Ultra - Low Diesel Spill

Tanks 116 + 115
OCD "corrective Action"

From: Chavez, Carl J, EMNRD
Sent: Tuesday, August 17, 2010 2:57 PM
To: Riege, Ed
Cc: Coleman.Simth@state.nm.us; Van Horn, Kristen, NMENV; VonGonten, Glenn, EMNRD
Subject: Initial C-141 T-116 Release Ultra-Low Sulfur Diesel Signed 8/20/2009 & Corrective Action (CA) Update (GW-032)

C-141 Final Report - Tank 116 Spill

Figure 10: Perforated pipe that has been constructed

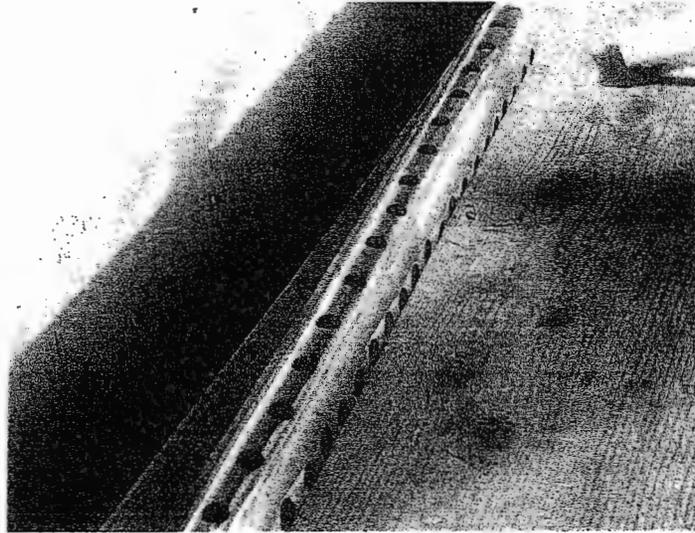
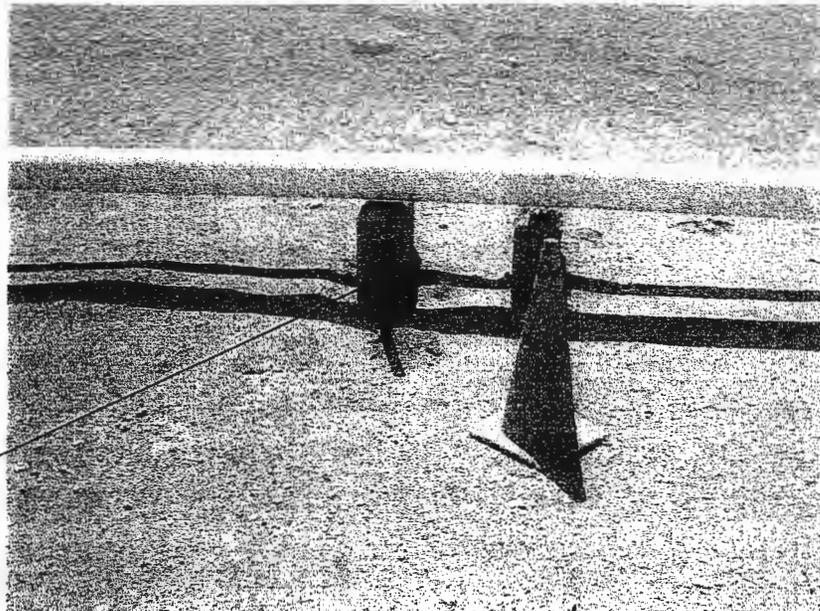
I think we need a diagram to scale in the TK 116 area to show what the system will look like. They will need to get below the 2 ft. backfill level and not sure why they would propose to bore only 2 ft. bgl? This is within the backfill and not into the contamination. The link above shows Figure 8 and the two contaminated areas between TKs 115 and 116 and west of them adjacent to the pipeline.

- 1) The placement of pipe 2 ft. below ground seems to position the vent pipe in the former excavation backfill. A deeper depth into the contaminated soils to facilitate more efficient venting is needed. Based on this, the agencies request the most efficient depth from Western and will there be peastone backfilled around the pipe?

- 2) A diagram(s) to scale with the pipe design and construction layout is requested to assess the actual aerial extent of the passive vent system and orientation of piping. Will there be vertical and radial and horizontal orientation of pipes from vertical?

As per your e-mail and the recently approved NSR Permit # (0633-M8-R3, A214 A.), Western Refining (Gallup) will proceed with installation of the Passive Bioremediation (Ventilation) System for Tank 116 area is estimated to be within the next thirty to forty-five days. This should allow enough time for the fabrication and installation of the ventilation network. There will be approximately 10 to 15 ventilation or perforated pipes that will be installed at 6 to 8 ft centers. The exact quantity of perforated pipe will vary depending on the extent of the contaminated area (1000 sq ft) as required. These pipes will be inserted to a depth of approximately one to two feet.

The pipe will be as specified and manufactured as follows: Piping: ID: 2 inch X 2 ft long, Holes: 24 holes drilled at 90 °apart with 2 inch spacing between rows.

Figure 12: Last set of data from a third sampling event

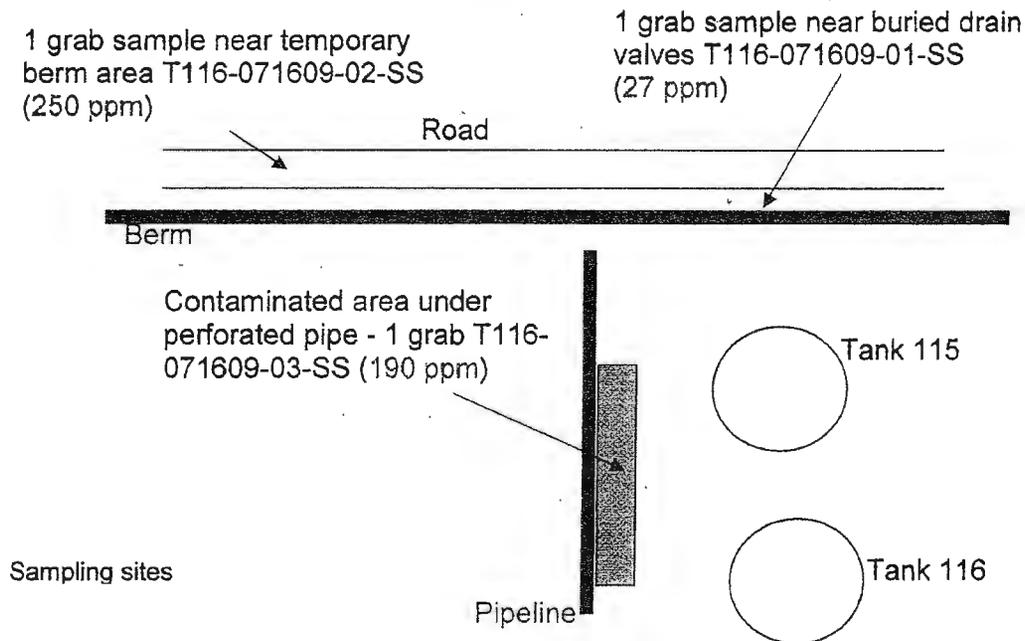
The T-116 report shows that the VOC emission rate dropped from 50,000 ppm before excavation, to 4700 ppm after excavation of 2' of soil, to 190 ppm after 1 year of the "passive bioremediation". Certainly this final VOC level is well within air quality standards, but the decrease in air emission rate doesn't necessarily mean that the diesel has been remediated. I could also mean that the spill has migrated below or away from the perforated pipe system.
